HISTORIC AND DESIGN REVIEW COMMISSION

HDRC CASE NO: 2019-190
ADDRESS: 148 SCHREINER PLACE
LEGAL DESCRIPTION: NCB 7054 BLK LOT 12& 13 & E 25 FT OF 11
ZONING: R-5,H
CITY COUNCIL DIST.: 1
DISTRICT: Monte Vista Historic District
APPLICANT: Eddie Fryar/Roel Construction LLC
OWNER: William Shea
TYPE OF WORK: Replacement of asphalt driveway with concrete pavers
APPLICATION RECEIVED: March 27, 2019
60-DAY REVIEW: May 26, 2019
CASE MANAGER: Stephanie Phillips
REQUEST:

The applicant is requesting a Certificate of Appropriateness for approval to remove the existing asphalt driveway with concrete panels.

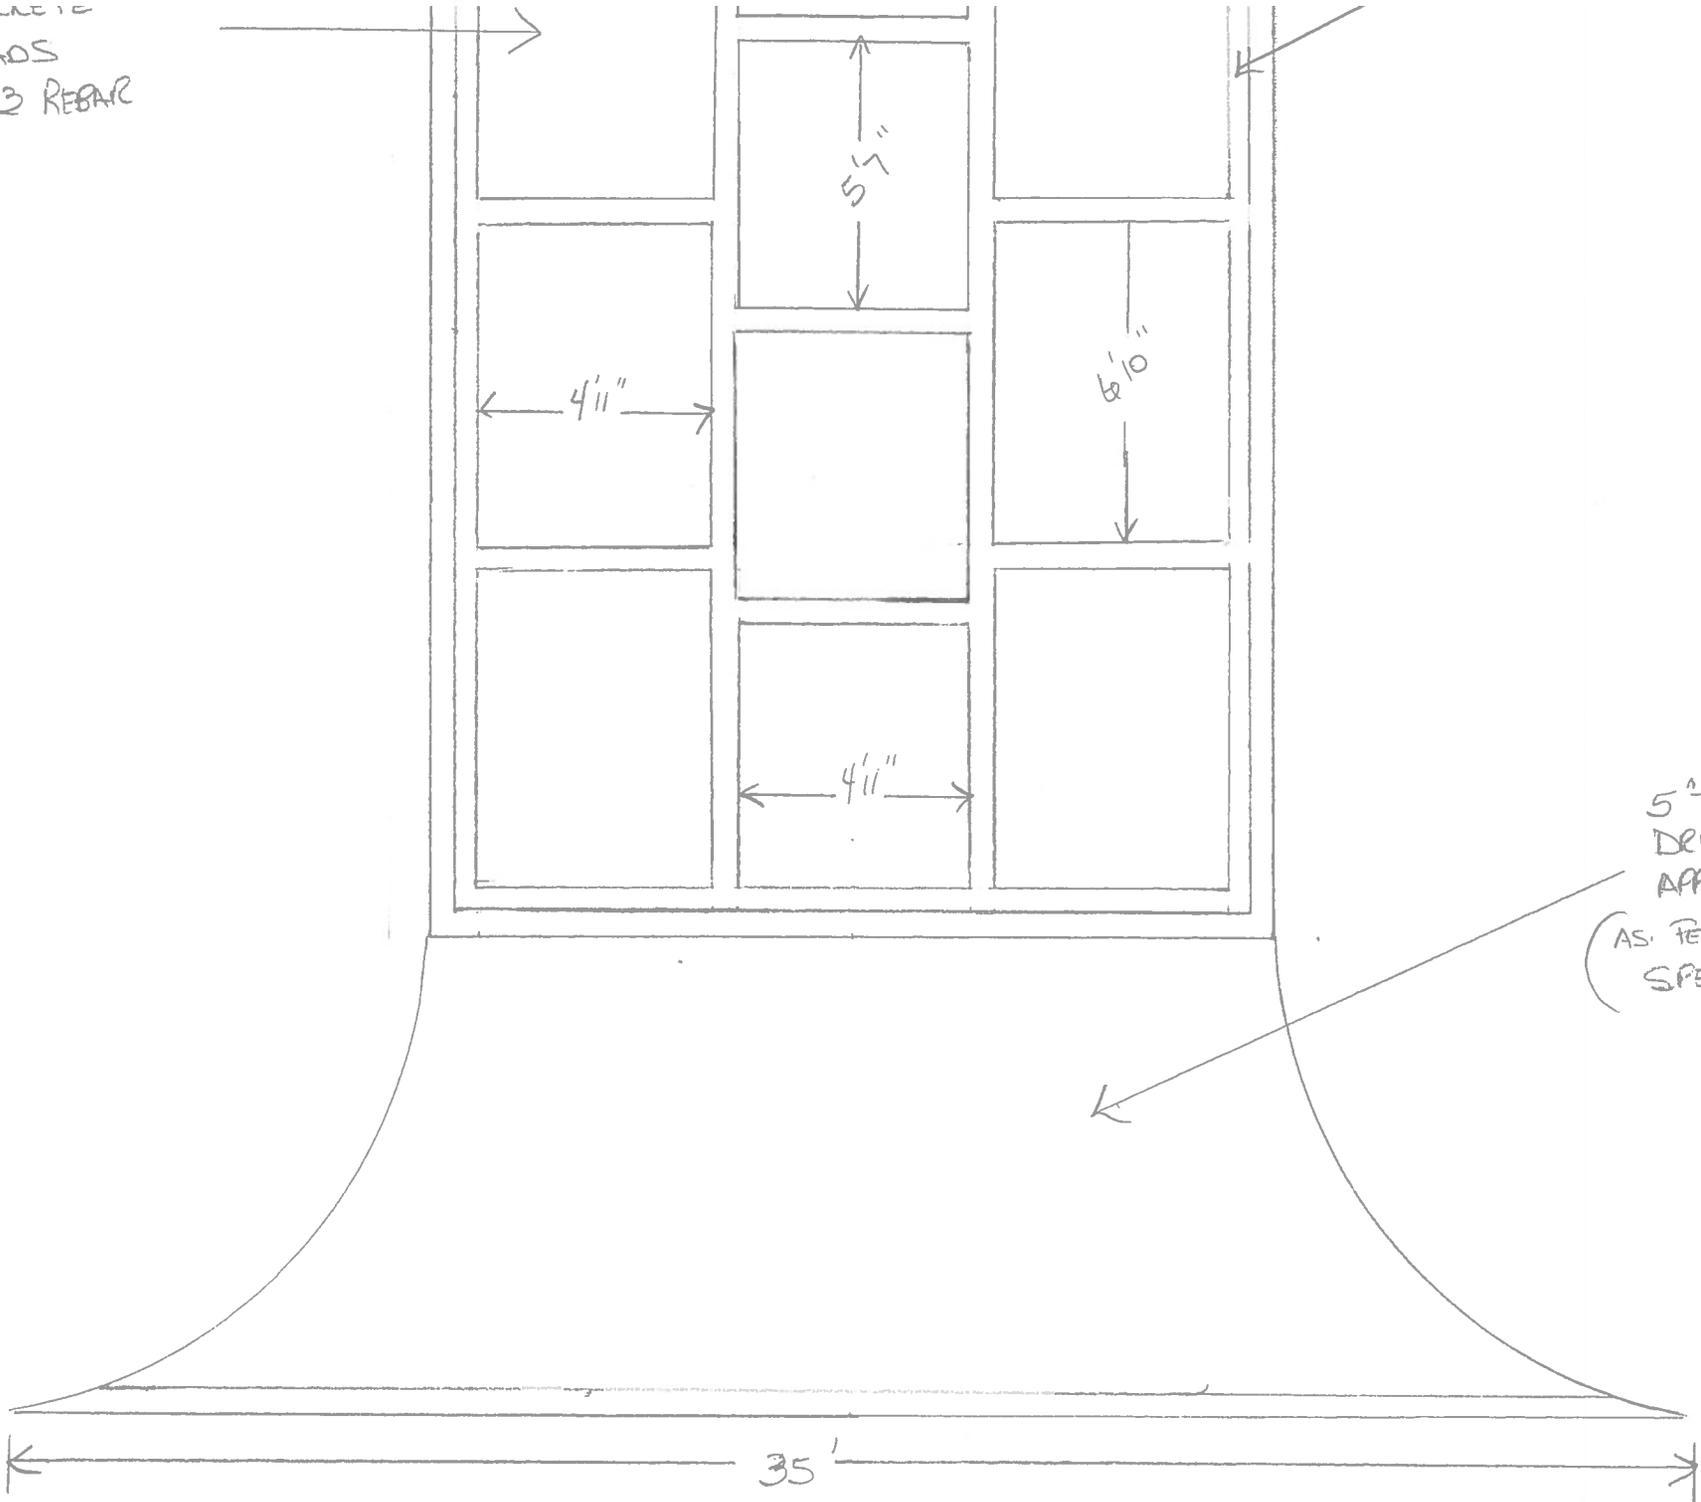
- b. **DRIVEWAY MODIFICATIONS** – The applicant has proposed to replace the existing asphalt driveway with gray cement pavers. The width and configuration of the driveway will be retained. According to the Historic Design Guidelines, replacement driveway elements should feature materials that are similar to those found on site or in the district. In the Monte Vista Historic District, driveways with pavers are evident, particularly on adjacent streets like Lynwood, Elsmere, and Kings Hwy. Based on the context of the district, staff finds the proposal appropriate.

Staff recommends approval based on findings a and b.
